STAFF REPORT
Decatur Zoning Board of Appeals

Hearing Date June 13, 2019
Case No. 19-04
Property Location 111/135 East Main Street
Request A variance to reduce the minimum front yard parking setback from five (5) feet to zero (0) feet along East Main Street and South Water Street, and to reduce the minimum parking aisle width required of the one-way, 60-degree angled parking spaces from eighteen (18) feet to sixteen (16) feet for the redesign and reconstruction of an existing parking lot at 111/135 East Main Street in the B-4 Central Business District.
Petitioner Main Place Properties LLC
Representative Mary Cave and Jonas Ozier, Chastain & Associates, LLC

PROJECT NO. 6582 PH 5	FIELD BOOK NO. 505-B	START DATE MARCH 2019	DRAWN BY CH/NO	CHECKED BY MEC	P&E REF. NO. 5590	FILE LOCATION 704
CHASTAIN & ASSOCIATES LLC CONSULTING ENGINEERS 184-001897						
SITE / SWPP PLAN PARKING LOT 111 E MAIN DECATUR, IL						
sheet no. C 4						
project no. 6852_PH 5

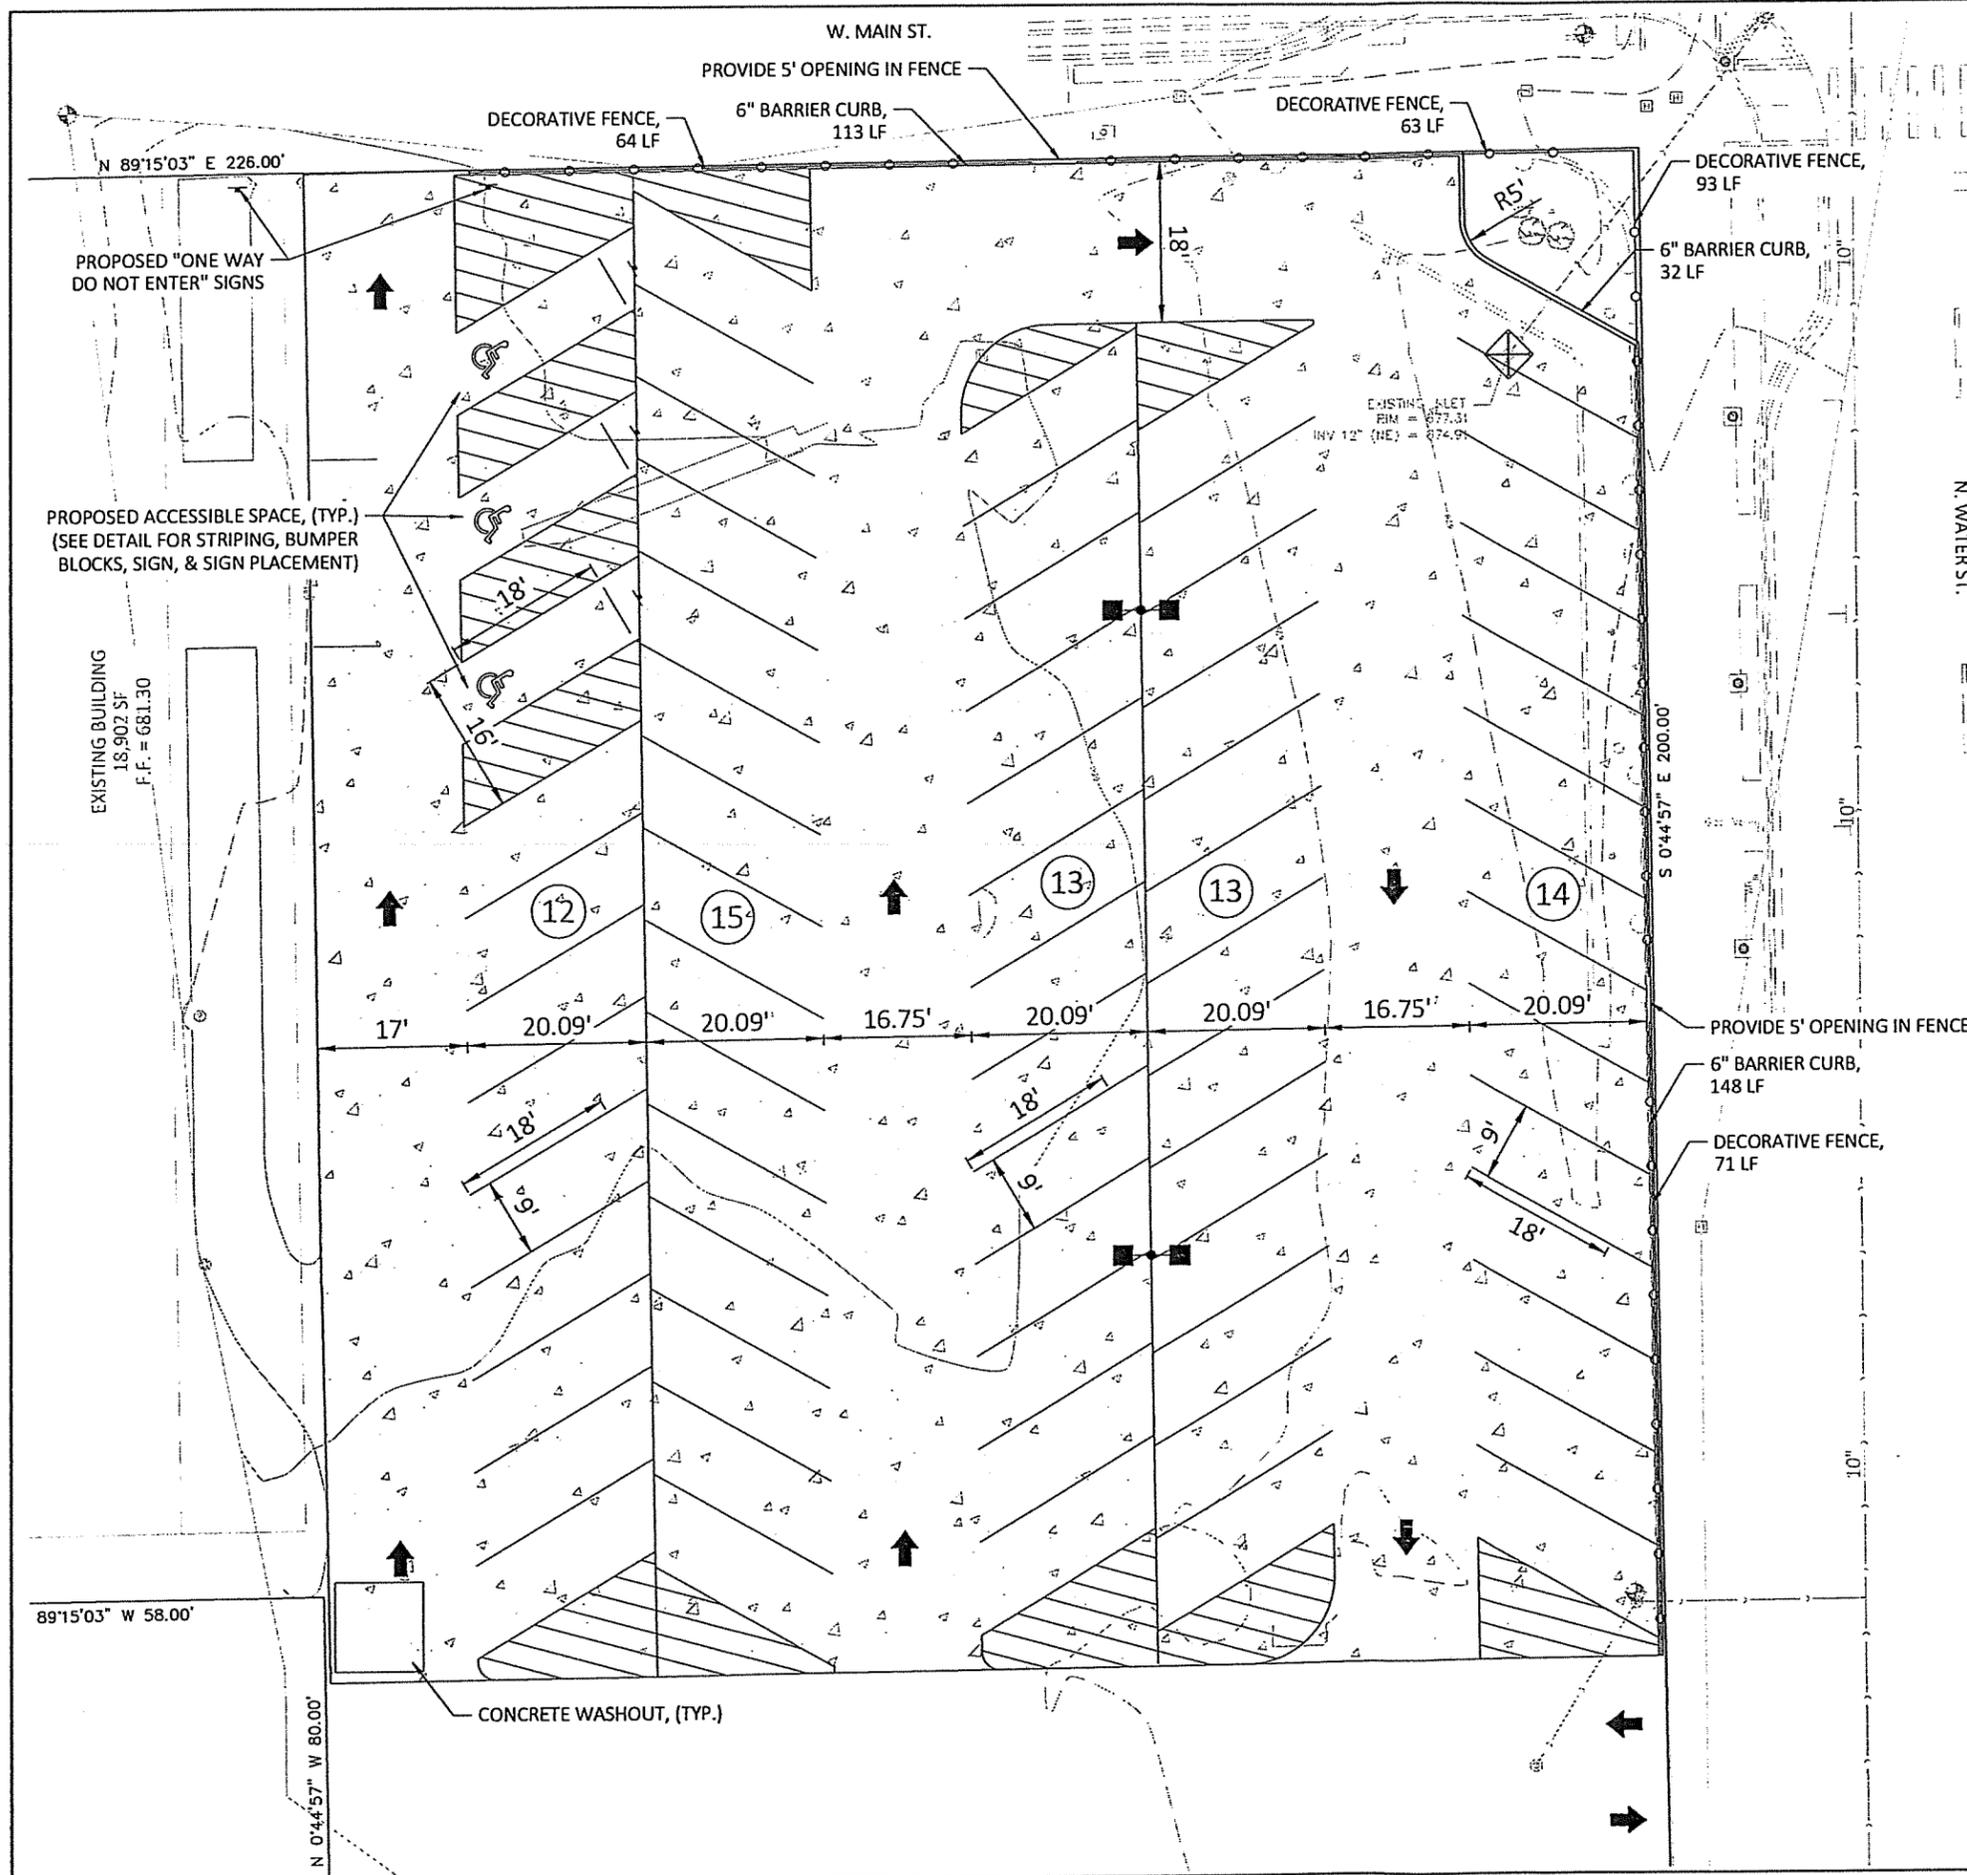
As shown on the proposed site plan, on the east side of the property line, a continuous curb is to be constructed instead of using parking blocks. Constructing a curb at the eastern property line would diminish the required eighteen (18) feet for the depth of angled parking spaces. While sixteen and three-quarters (16.75) feet is shown for the depth of the parking stalls to the east, the request is for sixteen (16) feet which, if approved, the redesign would be in compliance of this ordinance. This extra three quarters of a foot gives room to place parking blocks, a curb and fence along the parking limits. The petitioner has agreed to constructing a fence along north and east with openings at the property lines. This would provide a physical barrier to prevent vehicles from overhanging into the right-of-way or sidewalk. The petitioner’s request for a front yard parking setback of zero (0) feet in lieu of the feet (5) feet will be in harmony with the general purpose and intent of the Zoning Ordinance.

Staff believes granting a variance for reduced front yard parking setback and a reduced parking aisle width should not alter the essential character of the locality. The proposed sixteen (16) feet in lieu of the required eighteen (18) feet parking aisle width would narrow the aisle for traffic circulation within the parking lot. Nevertheless, the Institute of Transportation Engineers (ITE) recommends a minimum aisle width of sixteen (16) feet at a 60-degree angled parking stall. Other cities such as Bloomington, IL, Urbana, IL and Forsyth, IL allow the same minimum width. City of Decatur Engineering staff agree that sixteen (16) feet is a sufficient aisle width for a one-way circulation parking layout. Given review feedback from Engineering and Planning staff, research result of other cities, and the ITE support an aisle width of sixteen (16) feet between parking stalls on a 60-degree angle, therefore staff believes that the third standard can be met.

Staff recommends approval of the reduction of the front yard parking setback from five (5) feet to zero (0) feet, and the reduction of the minimum parking aisle width required of the one-way, 60-degree angled parking spaces from eighteen (18) feet to sixteen (16) feet subject to the following conditions:

1. Construct a continuous curb of minimum six (6) inch in width and height along the eastern property line and install parking blocks.
2. Install a rod-iron fence at minimum two and half (2.5) feet in height along the north and east property lines with openings for pedestrians.
